**CITY OF SNELLVILLE
DEPARTMENT OF PLANNING & DEVELOPMENT
MAYOR AND COUNCIL**

CASE NUMBER: RZ 20-01 CUP 20-01

DEVELOPMENT/PROJECT: Floral Shop & Auto Service and Repair Shop

**CASE ANALYSIS
June 22, 2020**

The proposed site plan, submitted by the applicant.

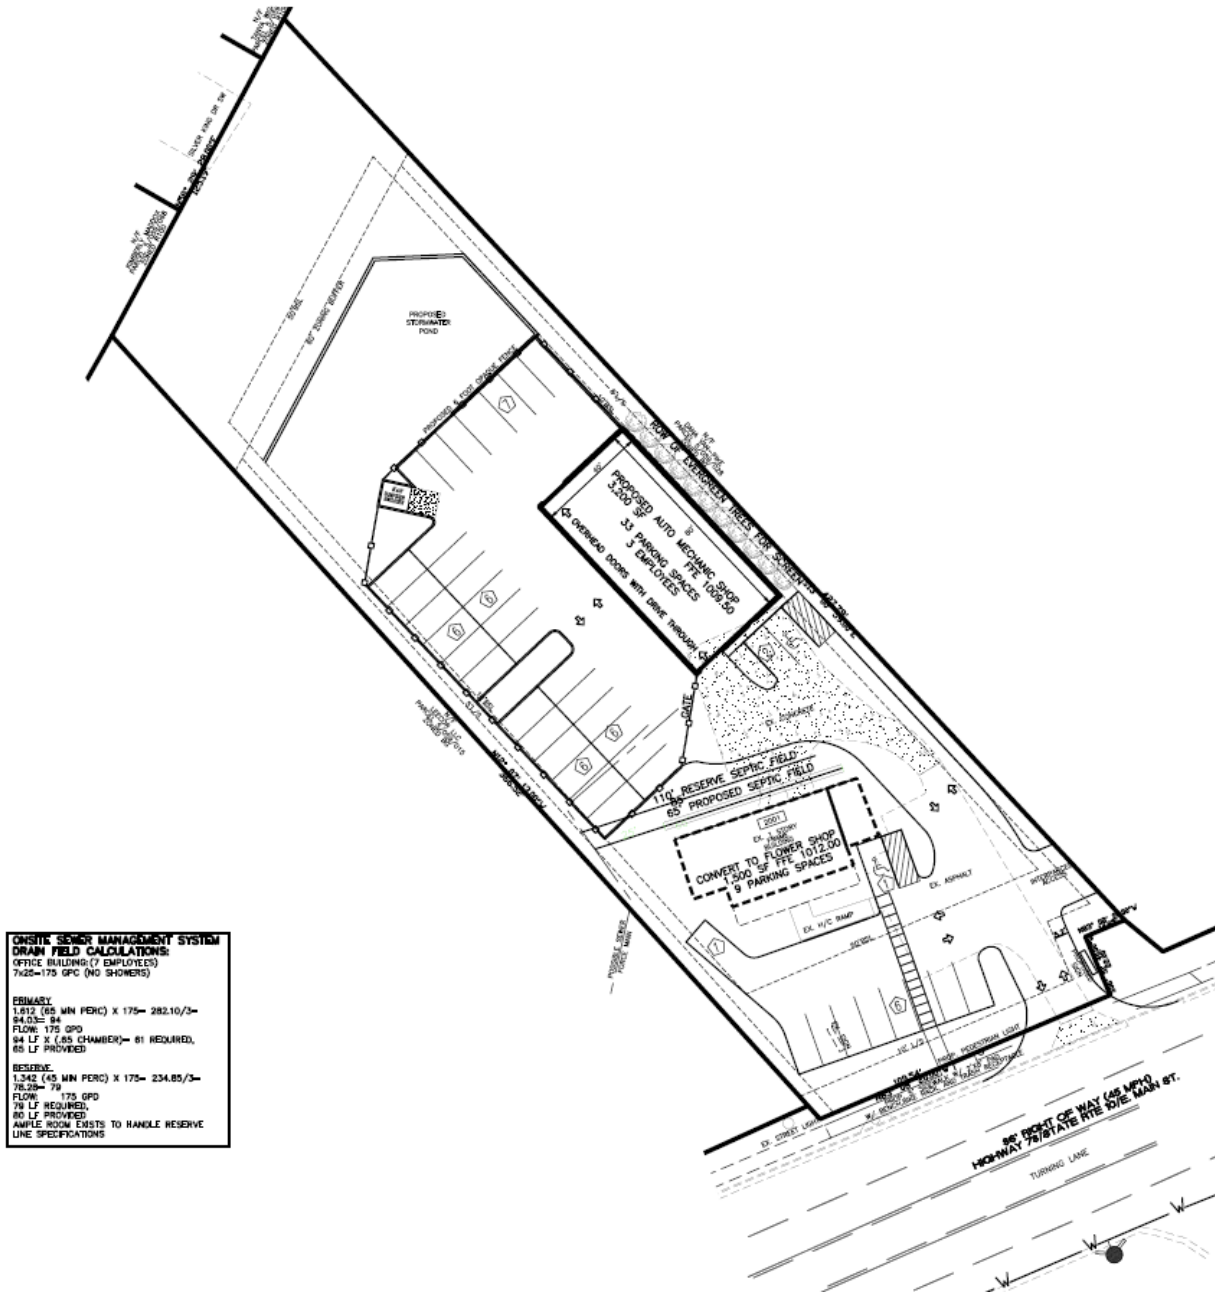
The existing structure is located in the southern portion of the property, and is setback approximately seventy-eight (78) feet from the US-78 / E. Main Street right-of-way. Improvements to the existing parking area include seven (7) parking spaces and one (1) handicap parking space located in front of the existing building.

The rezoning site plan shows a proposed five (5) foot wide sidewalk with small amenity pad for a pedestrian bench, trash receptacle and bicycle rack. One pedestrian light is shown adjacent to the amenity pad. Pedestrian connectivity between the sidewalk and entrance to the existing building is provided by a five (5) foot wide hatched walkway in the parking lot with a concrete walkway connection from the parking lot curb to the sidewalk. Although the applicant is proposing construction of a five (5) foot wide sidewalk along the right-of-way, in 2010 the adjacent property to the west (Future Services) was required to install a six (6) foot wide sidewalk per the City Code, so continuation of the six (6) foot wide sidewalk for this project will also be required (see Condition #7).

Although no monument sign drawings have been provided by the applicant, there is a proposed sign shown just east of the full-access drive. The final sign location may vary in order to comply with the sign ordinance requirements for sign type, sign area, sign height, and sign setback from the right-of-way.

An inter-parcel access stub is shown just to the east of the full-access drive that could provide future connectivity to the adjacent Family Tree Nursery property should they choose to make the final connection.

There is a two-way driveway that provides vehicle access to a 3,200 sq. ft. proposed auto mechanic shop and related parking. Two (2) parking spaces are shown in front of the proposed building with the majority of the parking to the side and rear of the proposed building. There are seven (7) spaces in the rear of the building and twenty-four (24) spaces along the side

The site plan shows sixty-five (65) feet of proposed septic system drain field with an additional one-hundred-ten (110) feet of reserve strip for future septic use. The nearest sanitary sewer manhole is located to the west approximately four-hundred-twenty-five (425) feet from the property line, well outside the threshold requiring connection to sanitary sewer.

One dumpster pad and enclosure is shown in the northwest corner of the mechanic shop parking lot. Although there is no dumpster pad and enclosure shown for the existing building, one shall be required to serve the future flower shop or other tenant use (see Condition #2). The code requires these enclosures to be eight (8) feet in height and made of brick, stucco, or split-face block.

Although no detail has been provided nor shown on the colored rendering, there is a proposed six (6) foot high opaque fence with gate will enclose the main parking area of the auto mechanic shop for security and screening of vehicles that are parked or stored outside.

There is a proposed stormwater detention pond located behind the auto mechanic parking area which includes a concrete retaining wall.

There is a sixty (60) foot undisturbed buffer shown that separates the proposed commercial use from the two residential lots of the Saddle Club Estates subdivision. Combined with the stormwater detention pond location, the proposed auto mechanic shop is approximately one-hundred-sixty-two (162) feet from the rear property line and the Saddle Club Estates subdivision.

1. The property shall be developed according to the site plan entitled “Rezoning Plan & CUP Plan for 2001 Main St. East”, dated 11-30-2019 and stamped received 1-14-2020, with modifications permitted due to engineering restraints, ingress and egress, and/or to meet conditions of zoning or State, County, and City regulations.

2. Applicant shall provide a separate dumpster pad and enclosure constructed in accordance with Sec. 19-34 of the City Code for use by the existing building tenant and shall be located in close proximity to the existing building.
